## Access Compliance Report Public Rights-of-Way (Curb Ramps)

Intersection ID: 19406 Main Street: SOUTH\_BV Cross Street: BOURBON\_ST Location: SE

ADA ID: F683755E50DA Ramp Type: Directional1 Initial Pass/Fail: Fail Overall Compliance: No Severity Score: 25

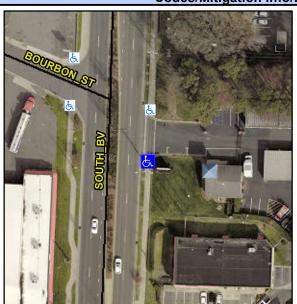
Possible Solutions:					
Remove & Replace Entire Ramp.					
Surveyor Notes:					
N/A					
PROW/ADA:					
R304.5.3
